HYDRAULIC LABORATORY REPORT NO. 168

INVESTIGATIONS OF THE HYDRAULIC PROPERTIES OF THE REVISED HOWELL BUNGER VALVE CITY OF SEATTLE, WASHINGTON

Subject: Investigations of the hydraulic properties of the revised Howell-Bunger valve, City of Seattle, Washington.

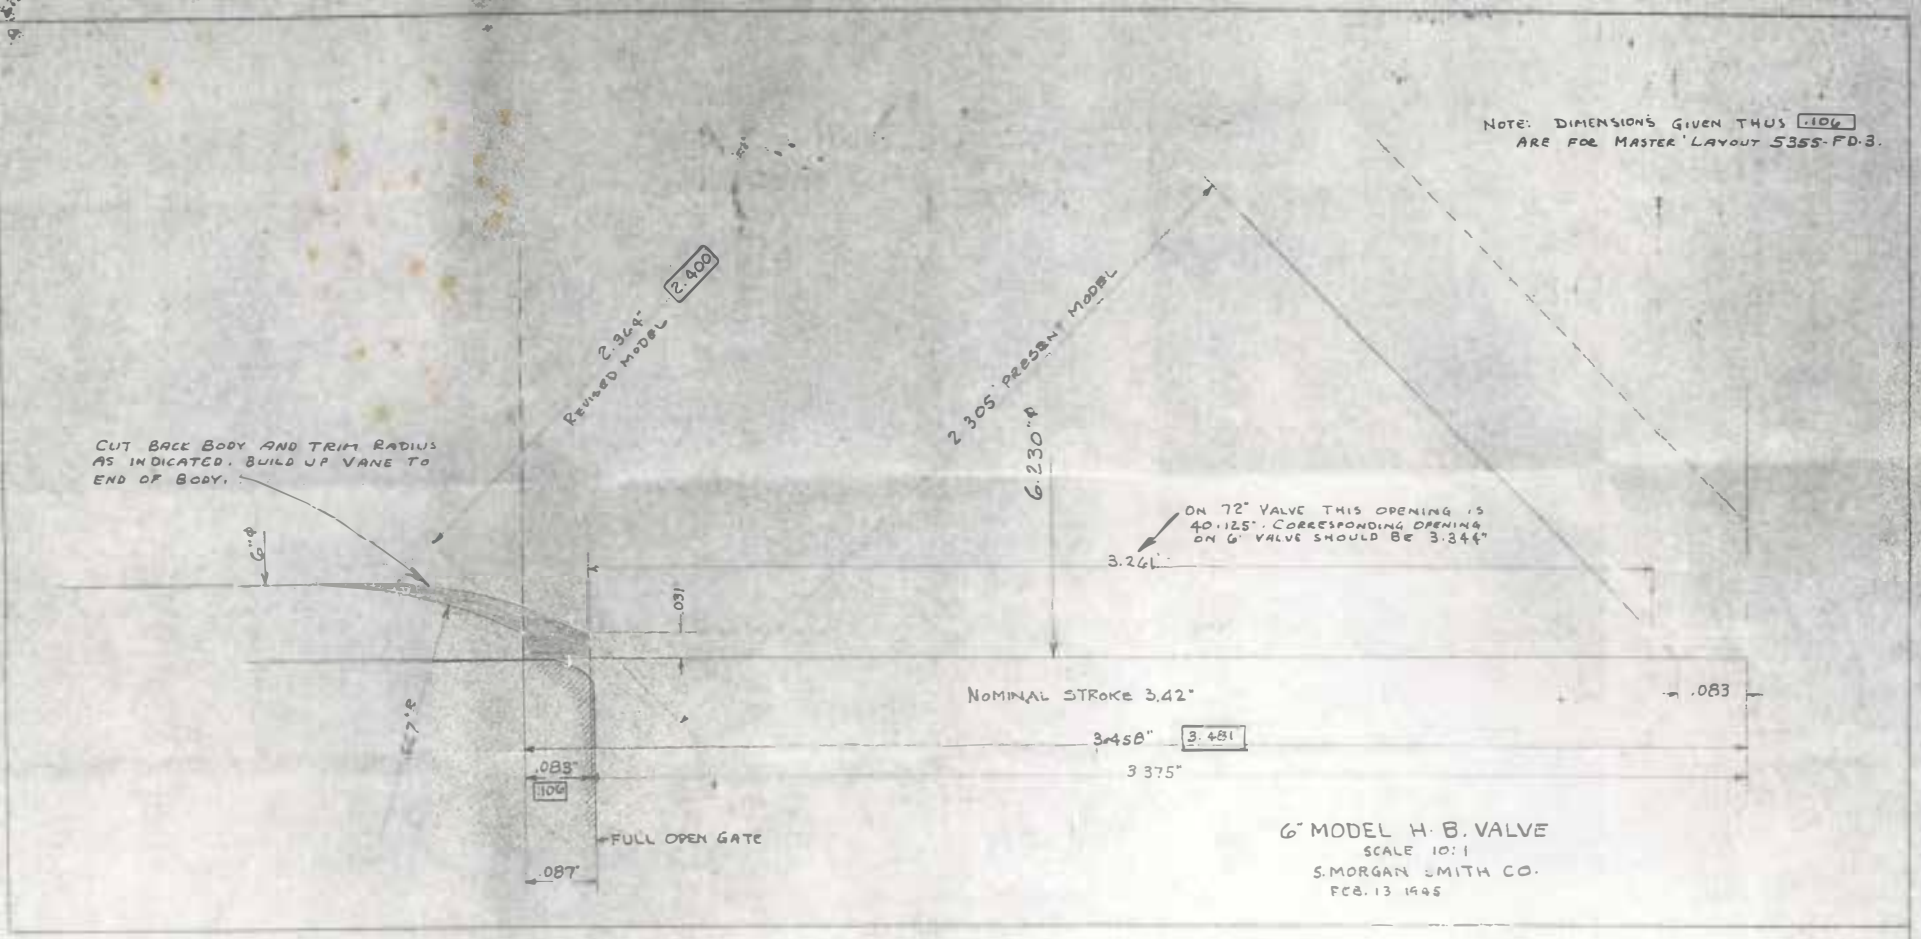
We have checked the data contained in your letter of January 17 and are enclosing one print of our sketch dated February 13 as well as photostat of your drawing, Figure 3, on the 6" Howell-Bunger model valve. In order to clarify the dimensions that are to apply to the model valve for the new test, we have made the sketch above referred to to scale ten-to-one, and you will note that in order to obtain the throat opening between cone and body sleeve, it will be necessary to trim back the body sleeve to the dimensions shown. We found that on the model valve the throat was not in accordance with the prototype due to the fact that allowance was not made for the depth of the rib slots in the cone. You will note that the throat opening should be 2.364" which, based on the master layout is the nominal opening to which is added a tolerance on fabricated valves to allow for assembly variations. We believe that the body can be cut back without much difficulty and the slots in the ribs could be built up again by soldering.

Referring again to our sketch you will note that the distance from the face of the cone to the end of the body sleeve is 3.458", which is not homologous to our master layout but includes the additional length of the cone due to the face that the outside length of .083" should be on a diameter of 6.188" instead of 6.230". This corresponds to a diameter of 73-3/4" on the 72" valve to which diameter the body is machined before the bronze liner is added. The bronze tips on the vanes are carried across the base of the cone and machined to 74-1/4" in diameter in line with the outside of the liner. This extra length again will not affect your further tests and we have, therefore, made allowance in the figure given above.

The end of the gate for full open should be positioned .087" from the end of the body sleeve and the nominal stroke is 3.42". Again the actual stroke on your model valve will be longer for the same reason as explained above, but for your tests we think the indicator should be calibrated for the nominal stroke. The strokes for the prototype will be determined on the same basis, namely, the location of the gate in full open position and the seat ring, the location of which may not always be truly homologous due to fabrication and machining considerations. Therefore, the strokes of various valve sizes may not be strictly proportional.

The data contained in your letter of February 16, 1945, in connection with the laboratory study of a 6-inch Howell-Bunger valve, shows that the valve seating arrangement has been dimensioned for a diameter at the base of the cone of 6.230 inches instead of the correct diameter of 6.188 inches. While it is probably true that this will not appreciably affect the discharge of the valve, the laboratory prefers that the valve be constructed such that all of the water passages are homologous so far as this is possible. The construction of the model valve is such that this alteration can be accomplished without removing the cone from the vanes and will require a very small amount of time.

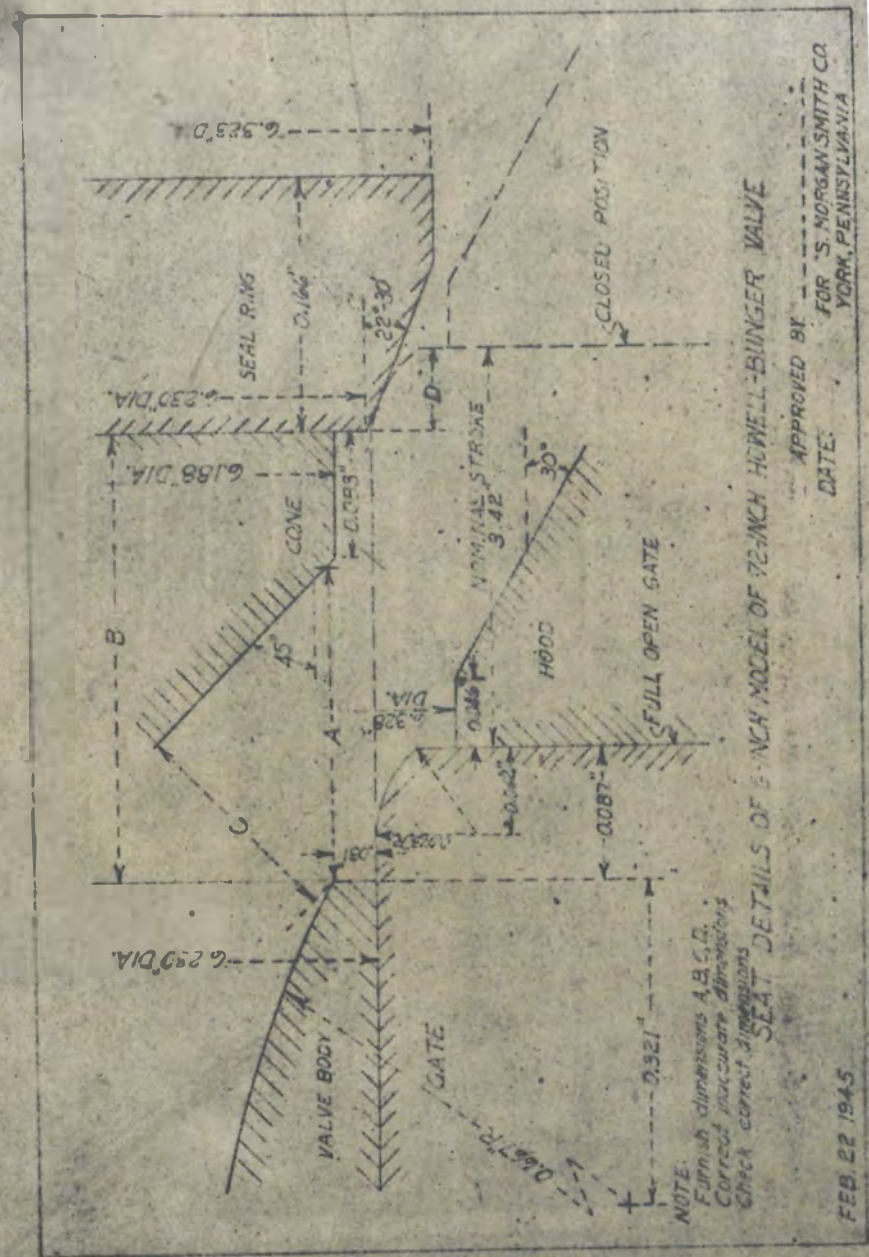
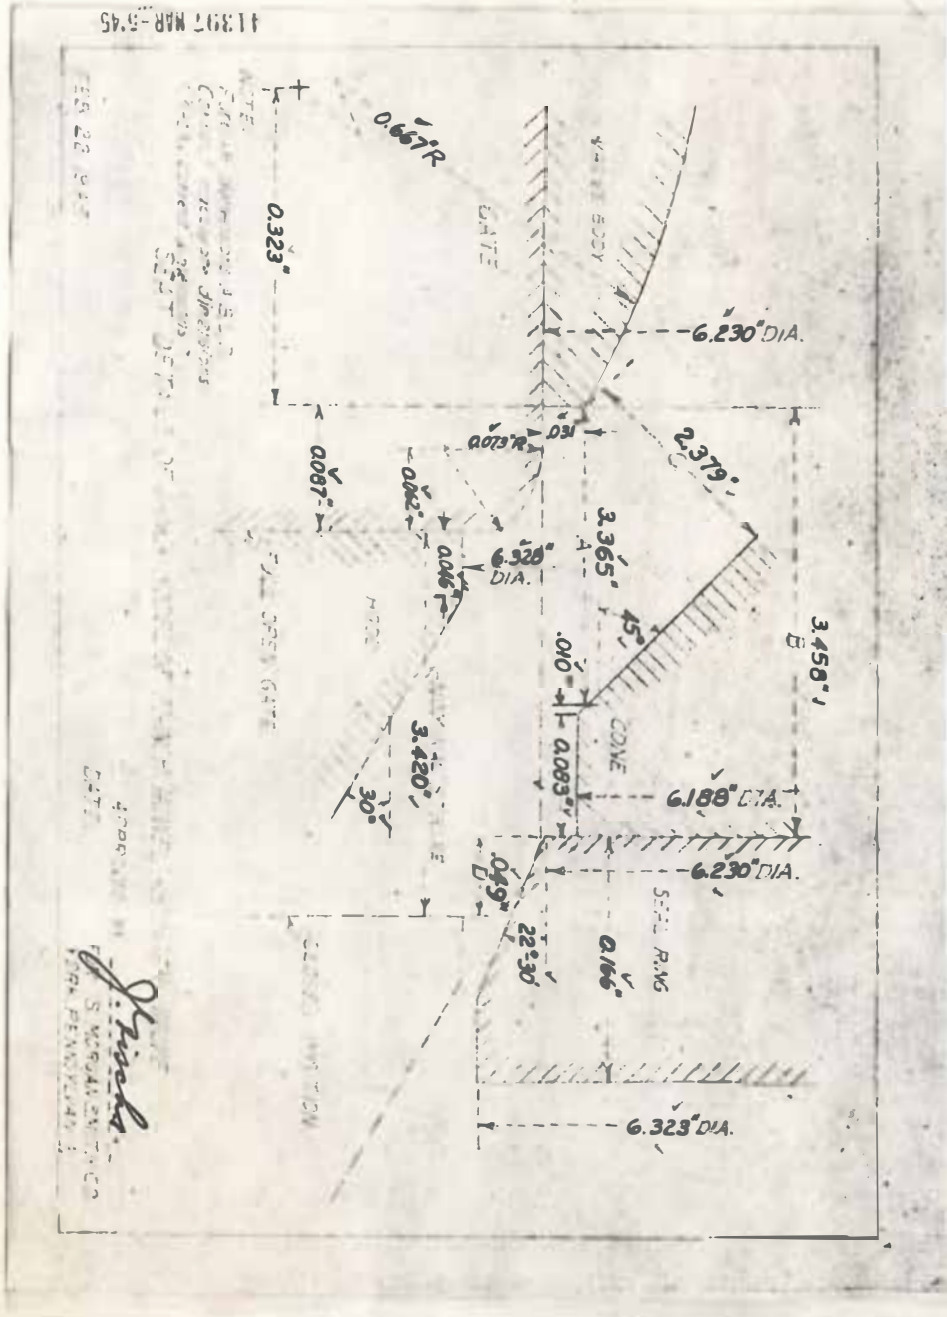
A drawing of the valve seat and the downstream part of the valve body is enclosed showing the dimensions A, B, C, etc., based on a diameter at the base of the cone of 6.188 inches which are needed to make the model valve conform with the prototype. For our purposes it will be preferable for the missing dimensions to be placed on the drawing and to return to this office either the original or a photostat copy.

Enclosed we are returning to you sketch dated February 22 on which we have indicated the desired dimensions. All other dimensions originally shown on the print were checked and found to be correct.

Since you are machining the cone part of the valve, we wish to call to your attention that not only the diameter must be reduced to 6.188", but the face must be machined off to a dimension of .083", from the intersection of the cylinder with the 45° cone.
